ADDENDUM # 002

**Our Lady of Fatima
545 Baldoon Rd
Chatham, ON**

New Exterior Wall Assembly, Universal Washroom and In-coming Water Service Project No. 619-CP1835

June 4th. 2018

ASK-013 – Parapet Detail:

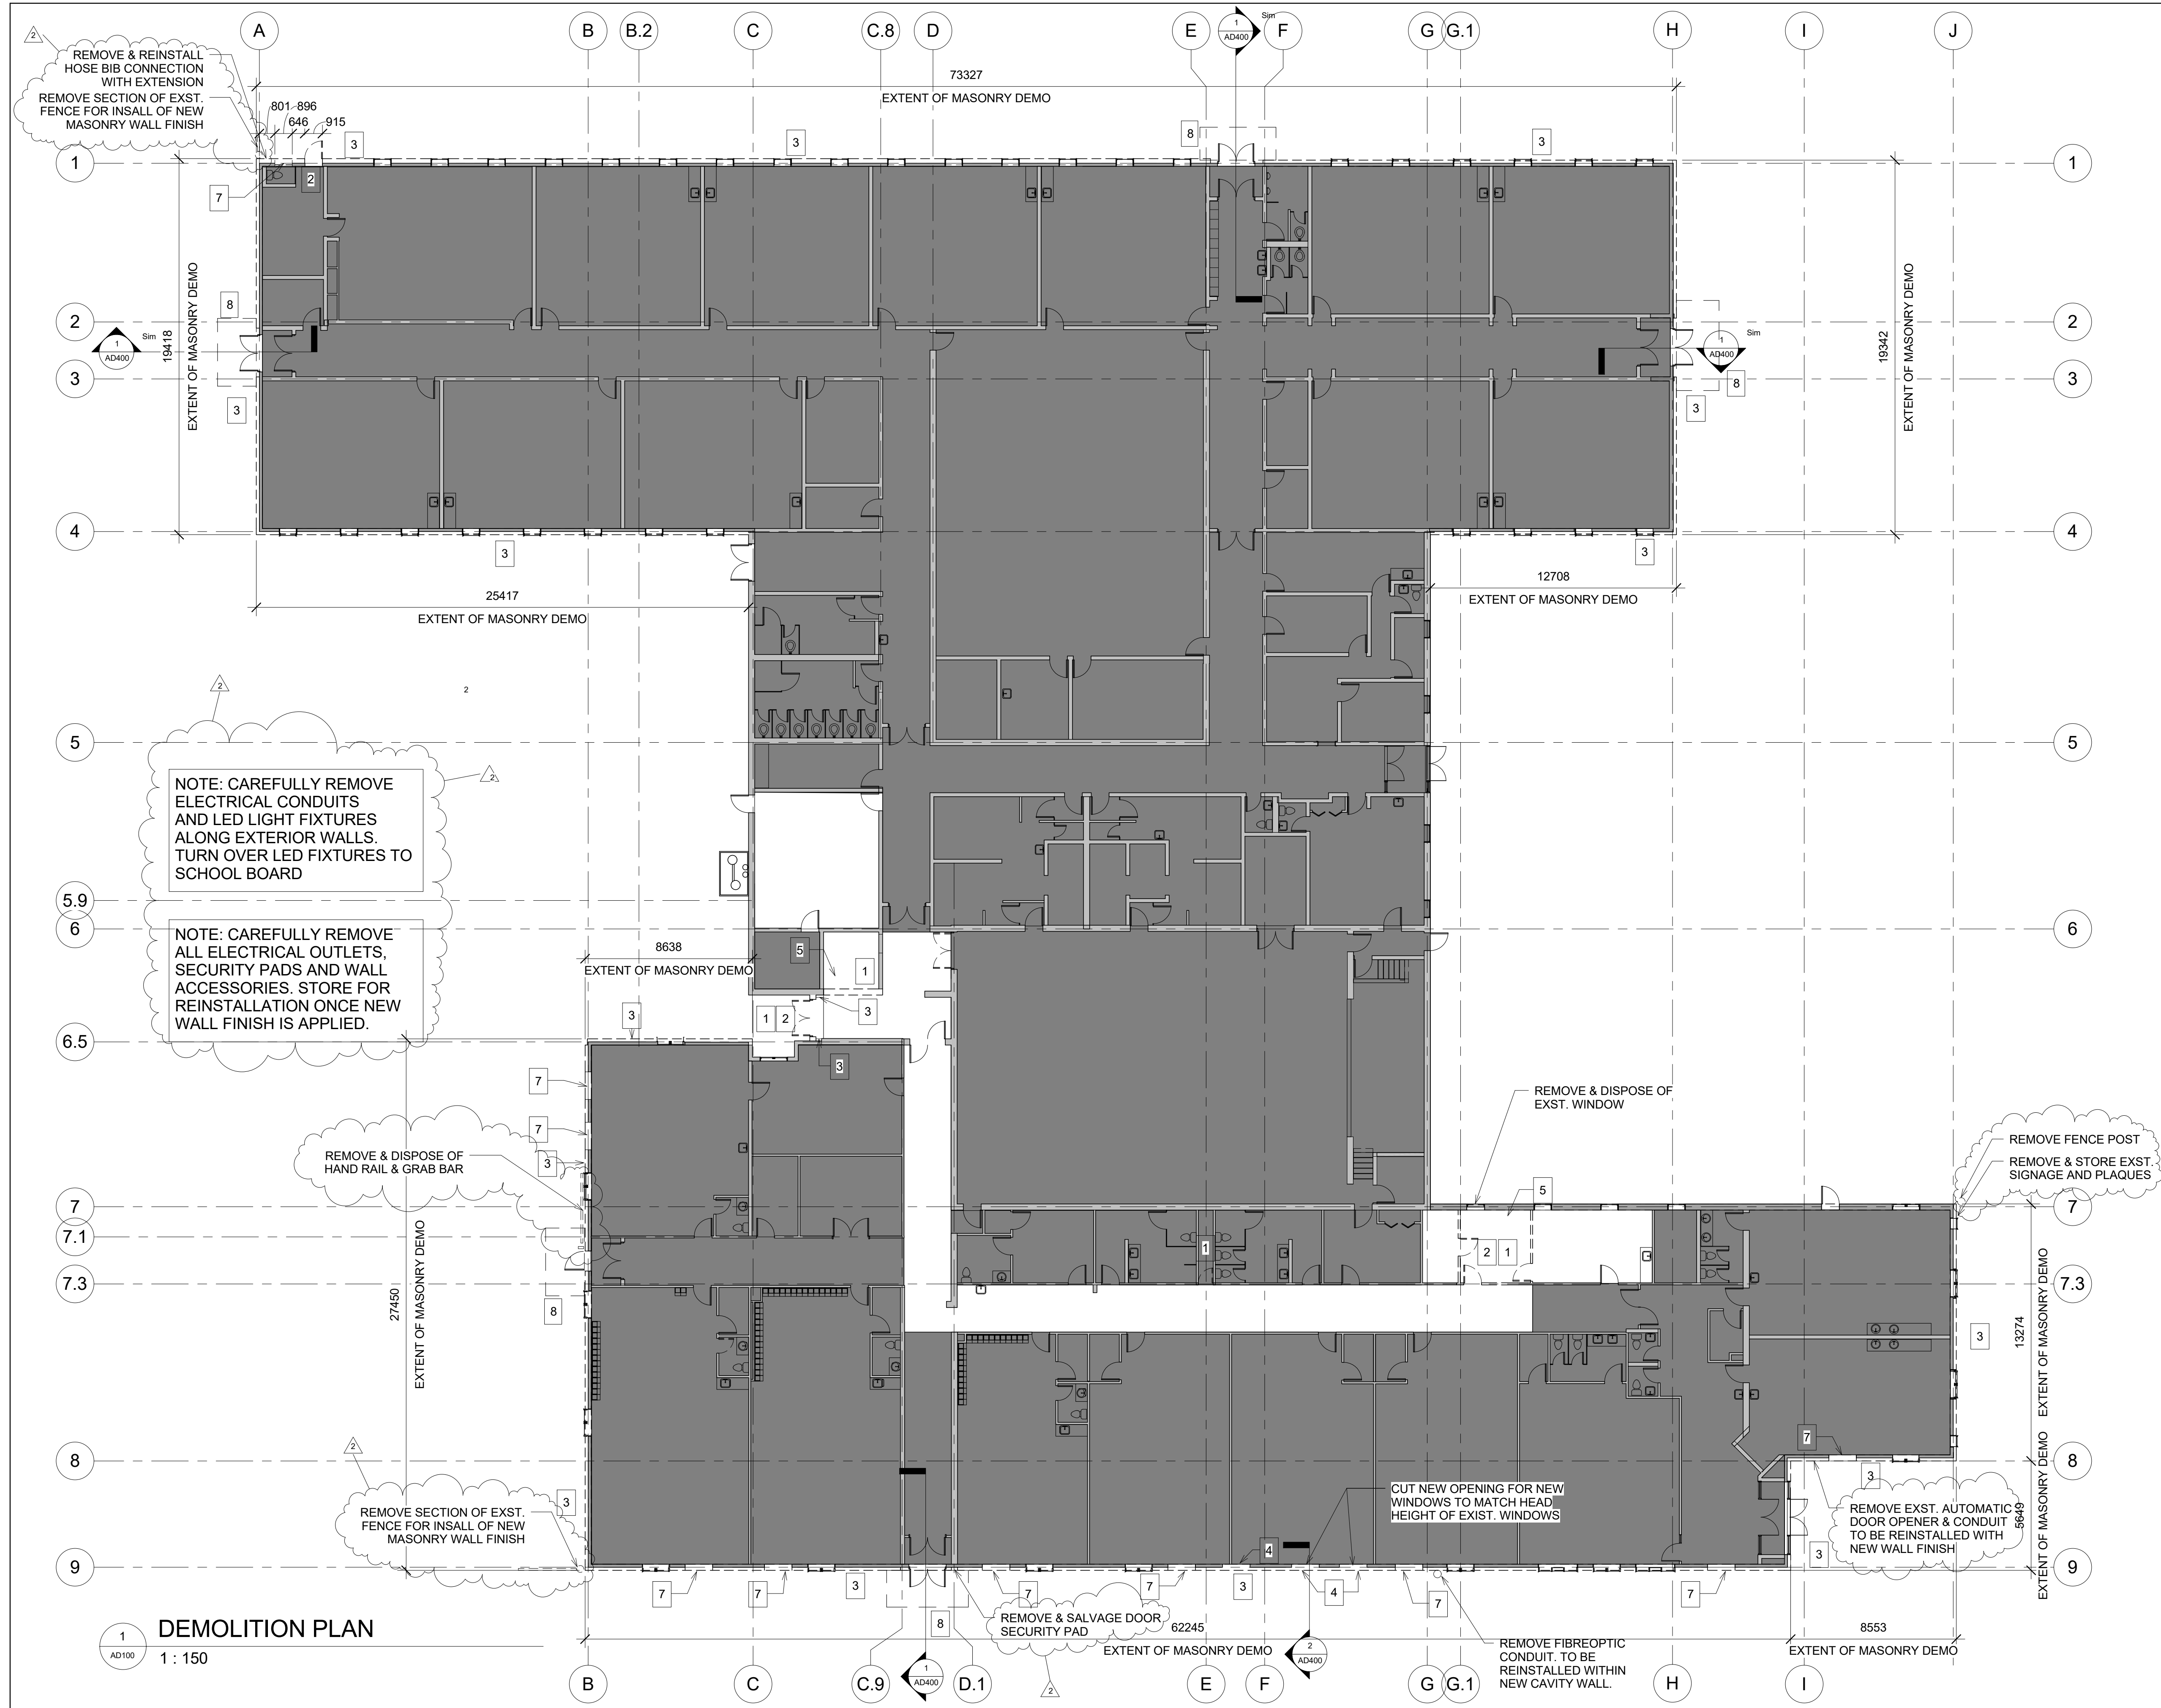
1/A650 – Parapet detail at North end of wall to match the height of the parapet at the South end wall. Dimensions to be confirmed on site.

DRAWING TITLE
DEMOLITION PLAN

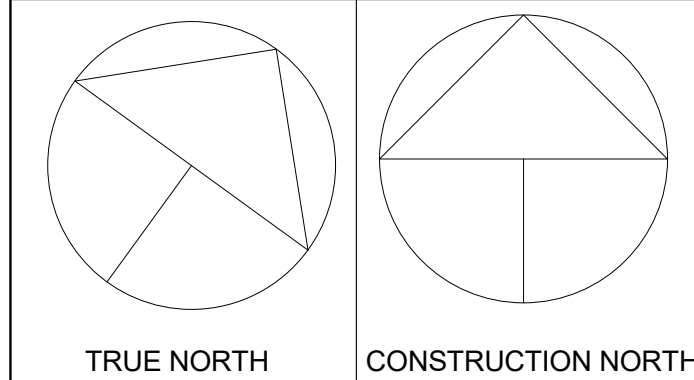
AD100 – Ground Floor Demolition Plan: Reissued to illustrate new changes to the scope at the west end of the school, and around the perimeter. Note that existing exterior doors are to remain, but the brick around the doors will be removed.

DRAWING TITLE
WALL SECTIONS

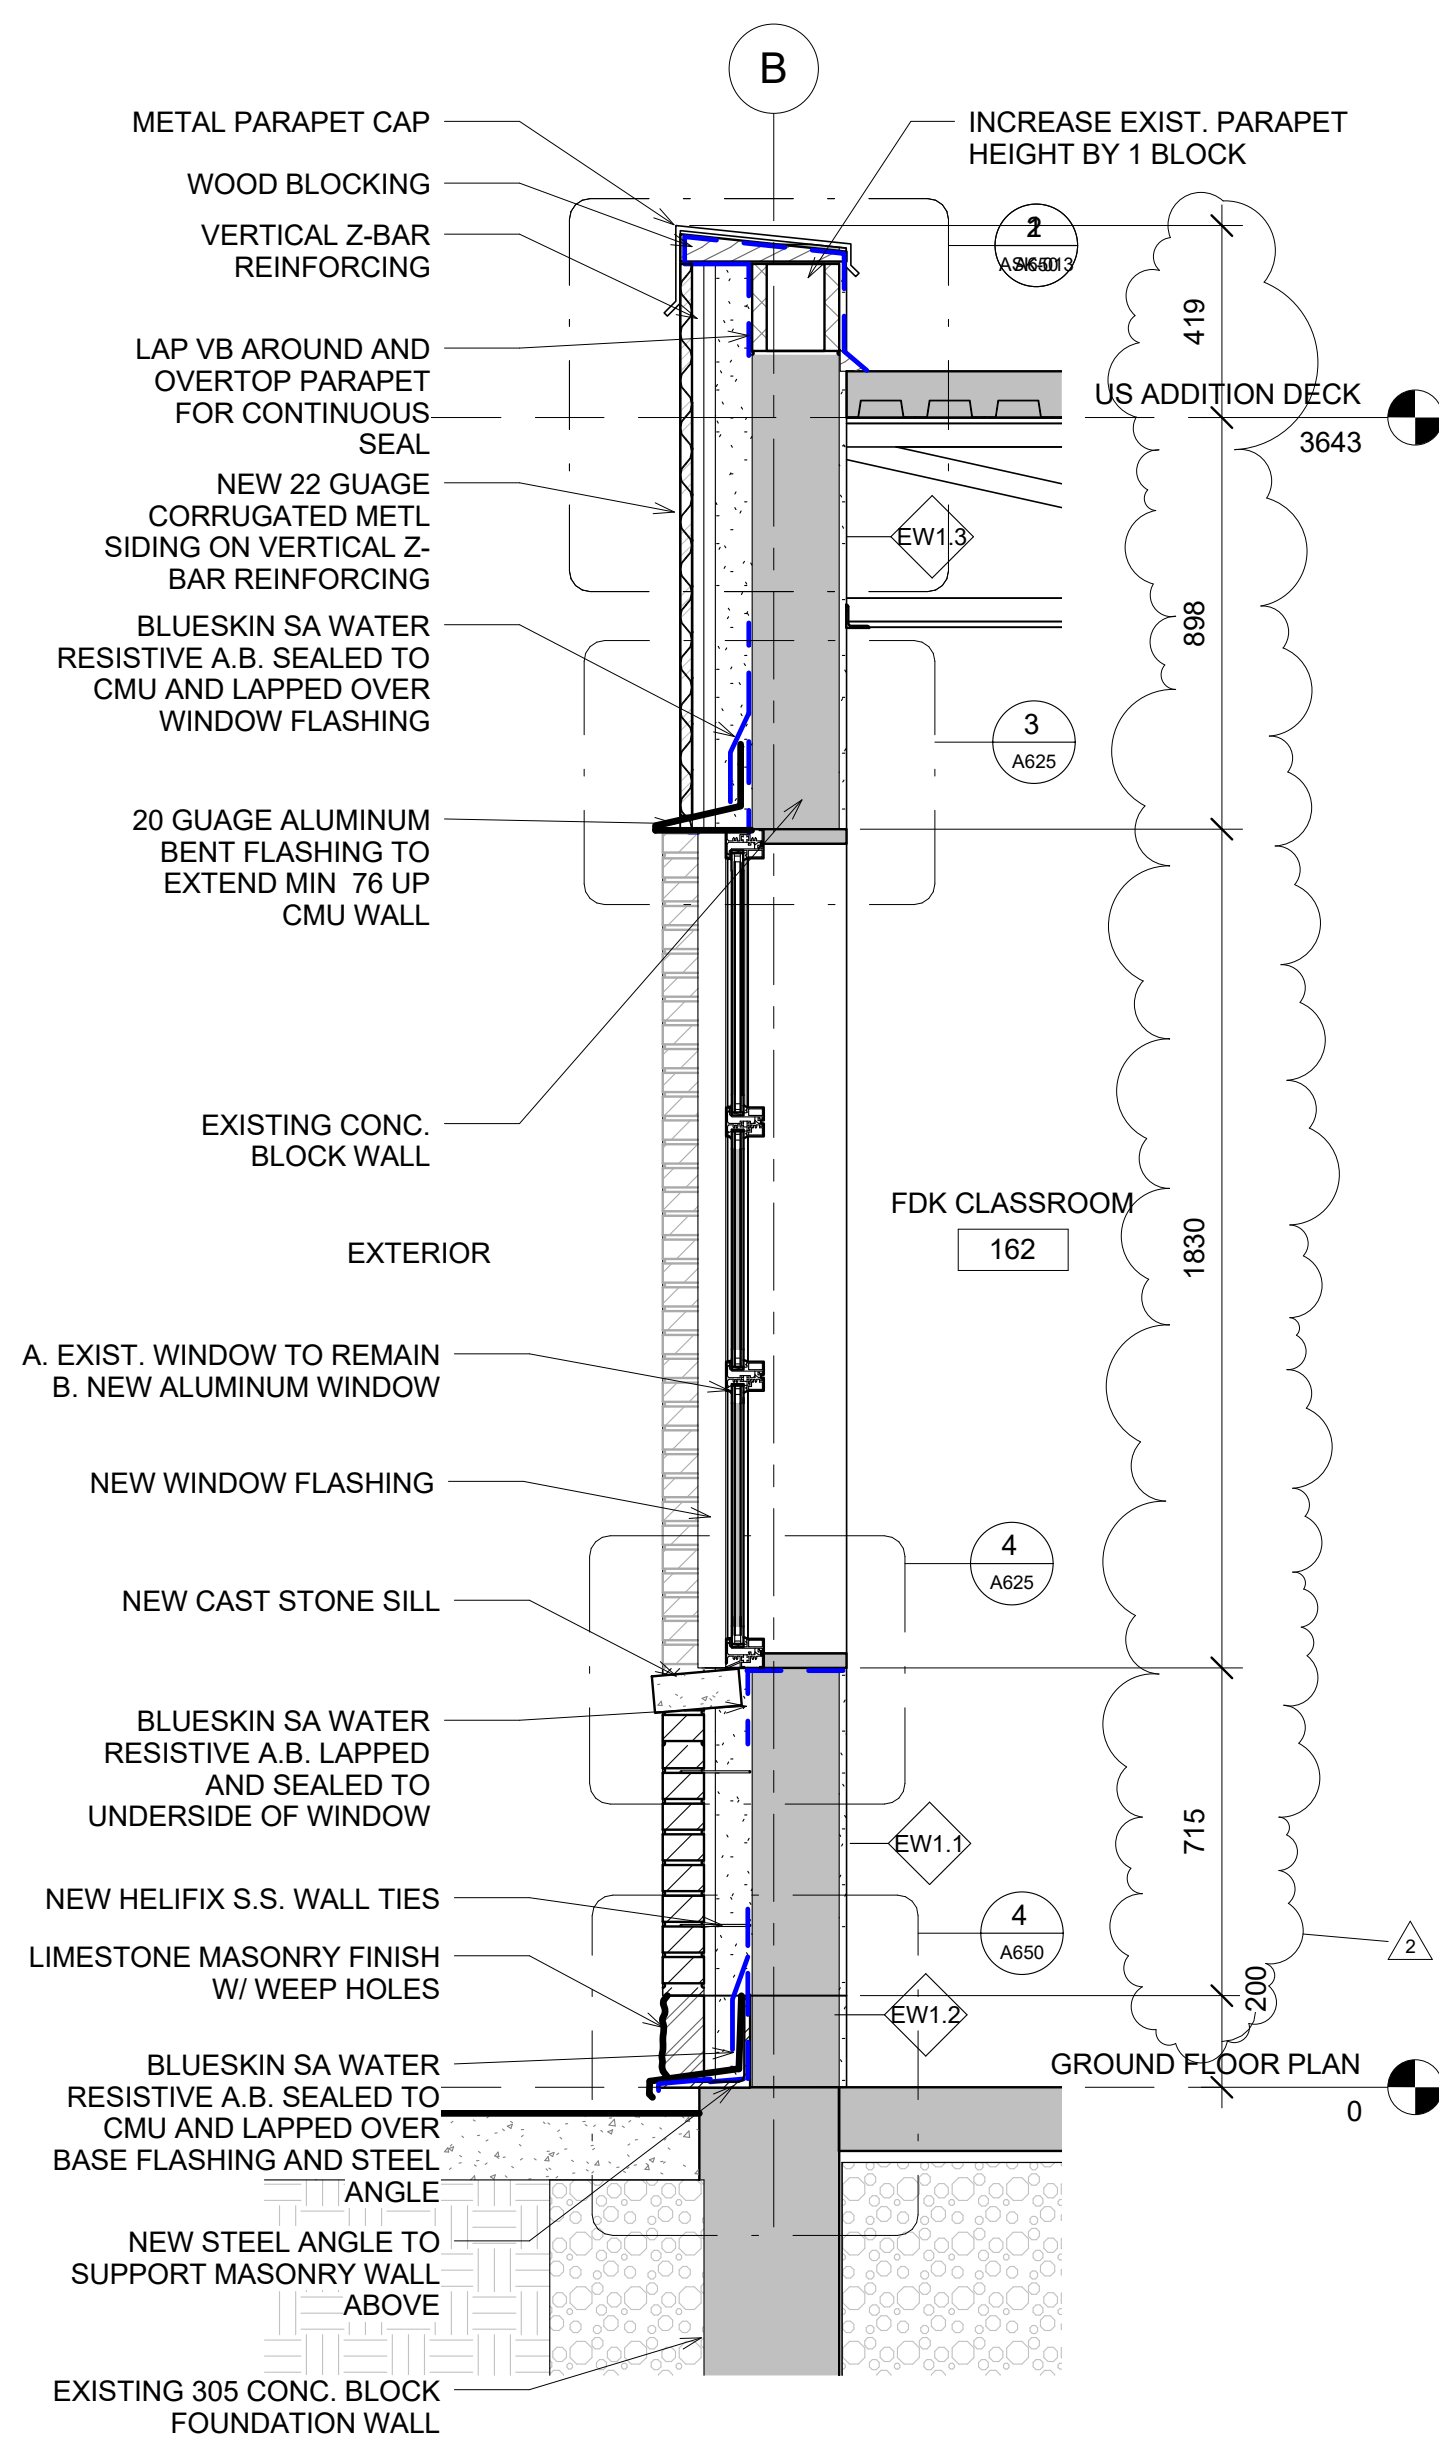
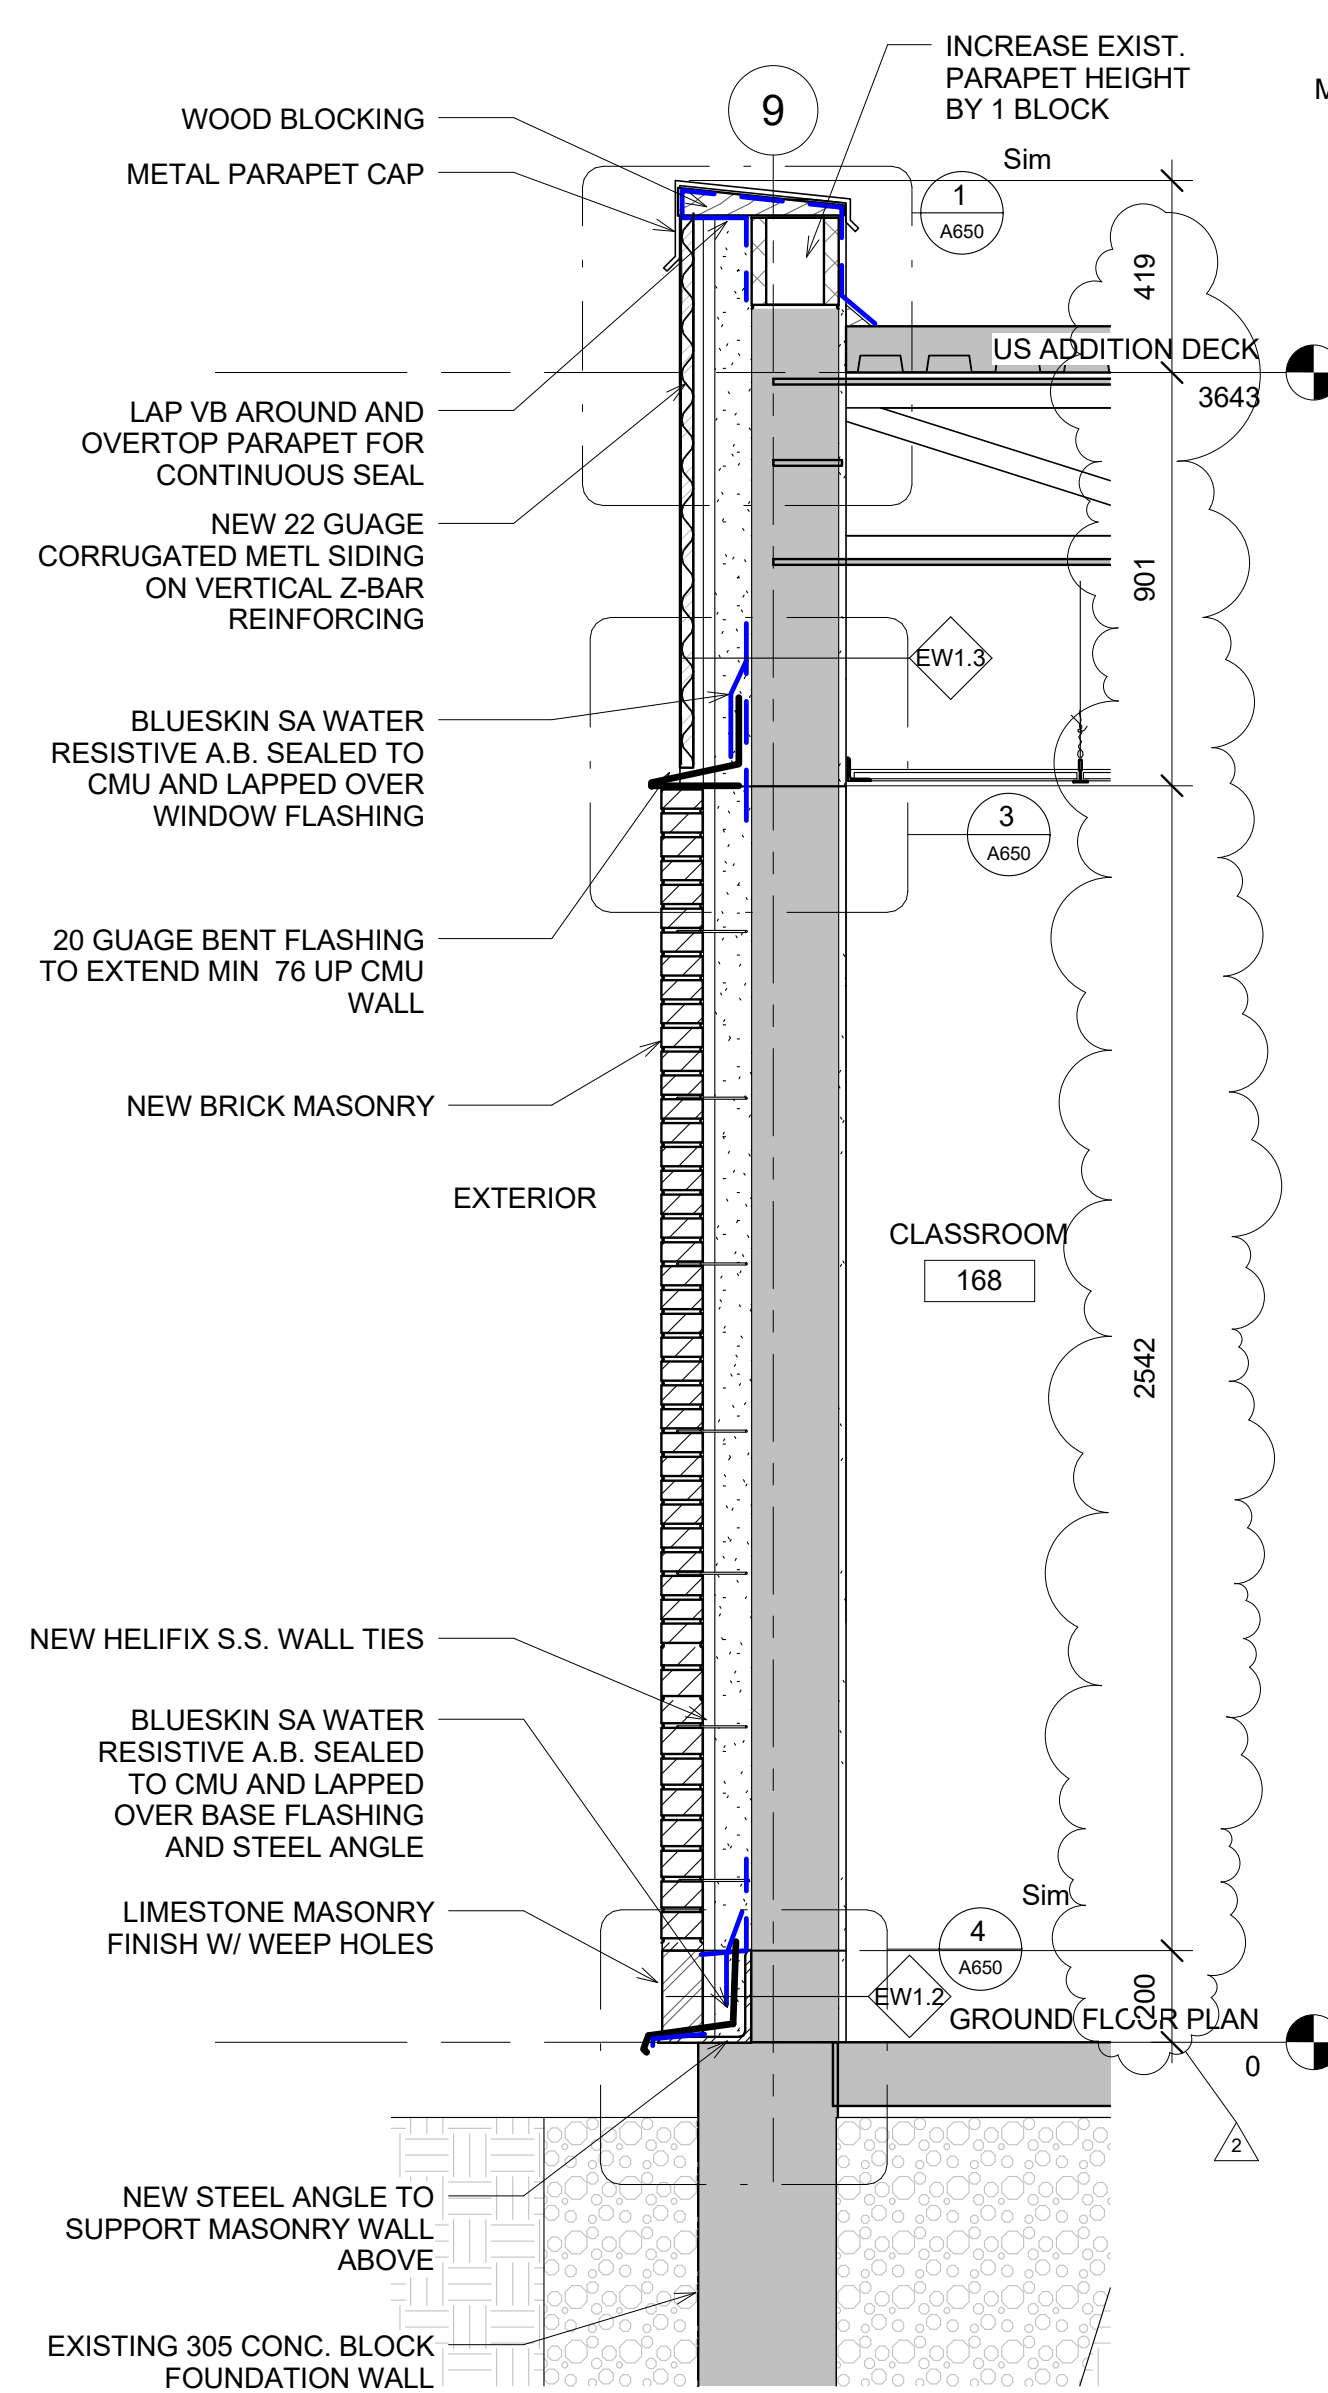
A500 – Wall Sections: Reissued showing the wall dimensions and parapet heights.
